Corrections Needed in Clause 180.9.6

Norman Swenson
Affiliated with Nokia, Point2
Aug 27, 2026
Revision a

Addresses Comments: R2-188, R2-189, R2-16, R2-17, R2-18

Figure 180–10—TDECQ reference equalizer functional model

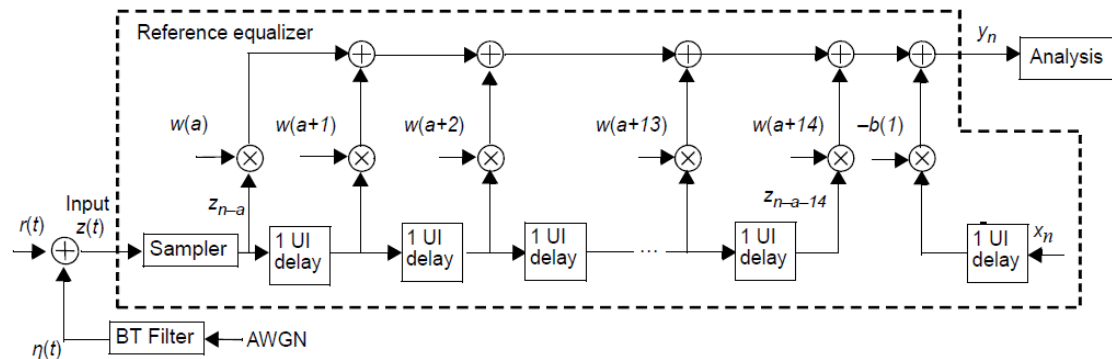
$r(t)$ is no longer a power, as the mean has been subtracted off, and y_n is a discrete-time signal, not a continuous-time signal. The method defined in 180.9.5 is for a continuous-time signal with runs of threes and runs of zeros. I suggest introducing a continuous-time signal when we introduce the eye diagram, then use that to define OMA_{TDECQ} .

The eye diagram reflects a continuous-time waveform $y(t)$ corresponding to y_n , where $y(t)$ would be the output of a continuous-time equalizer obtained by removing the sampler in Figure 180-10.

x_{n-1} changes value to x_n at time $t = nT + \phi_0 + T/2$.

Figure 180–11—Illustration of the TDECQ measurement

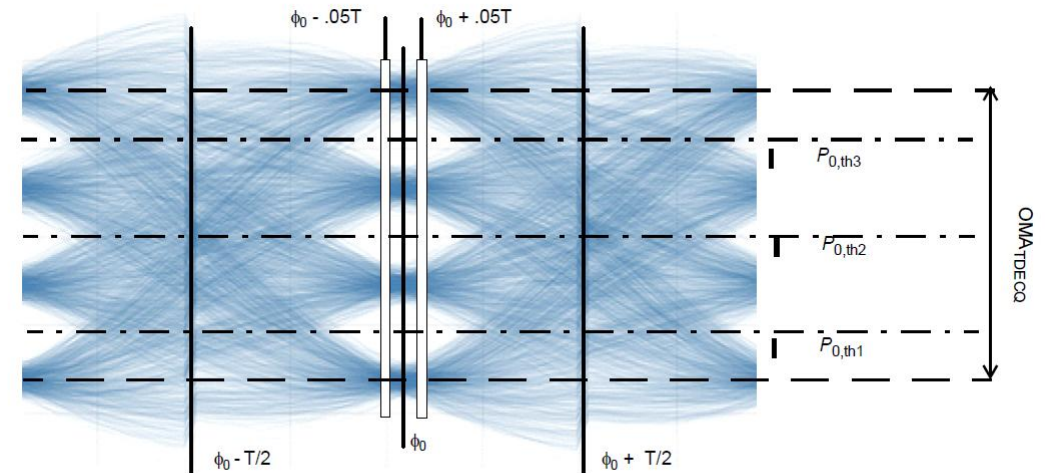
An eye diagram to help illustrate TDECQ is shown in Figure 180–11. The eye diagram corresponds to the optimized equalizer setting at sampling phase ϕ_0 . The feedback symbol x_n changes at phase $\phi = \phi_0 - T/2$.

An eye diagram to help illustrate TDECQ is shown in Figure 180–11. The eye diagram corresponds to the optimized equalizer setting at sampling phase ϕ_0 . The feedback symbol ~~x_n changes at phase $\phi = \phi_0 - T/2$.~~

The nominal threshold levels $P_{0,th1}$, $P_{0,th2}$, and $P_{0,th3}$, are ~~determined from the OMA_{TDECO} and the average optical power P_{ave}~~ defined in Equation (180-4), Equation (180-5), and Equation (180-6), and illustrated in Figure 180-11.

$$P_{0,th1} = \cancel{P_{ave}} - \frac{OMA_{TDECO}}{3} \quad (180-4)$$

$$P_{0,th2} = \cancel{P_{ave}} \quad 0 \quad (180-5)$$

$$P_{0,th3} = \cancel{P_{ave}} + \frac{OMA_{TDECO}}{3} \quad (180-6)$$

where OMA_{TDECO} is measured on the equalized captured waveform $y(t)$, using the method defined in 180.9.5, and where $y(t)$ is the continuous time waveform corresponding to the eye diagram shown in Figure 180-11.
